No. B2608 P.W.B. for 853

CAUTION

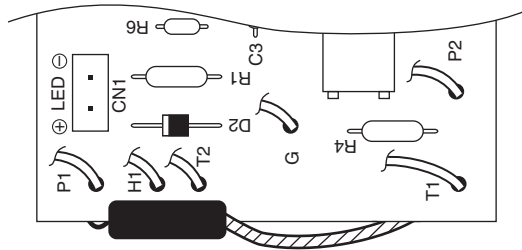
Before replacing the 853 P.W.B., look for how the capacitor is soldered to the board that is being replaced. Attach the supplied tube to the lead of the capacitor, and solder between T1 and P1 on the soldered side of the new P.W.B. as illustrated below.

No. B2608 P.W.B. for 853

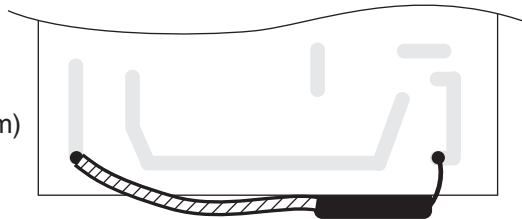
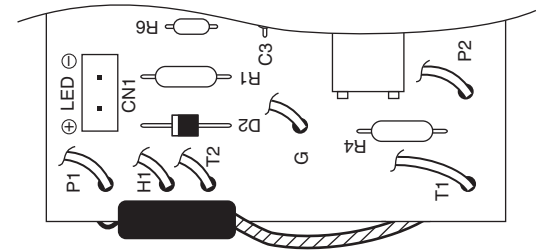
Before replacing the 853 P.W.B., look for how the capacitor is soldered to the board that is being replaced. Attach the supplied tube to the lead of the capacitor, and solder between T1 and P1 on the soldered side of the new P.W.B. as illustrated below.
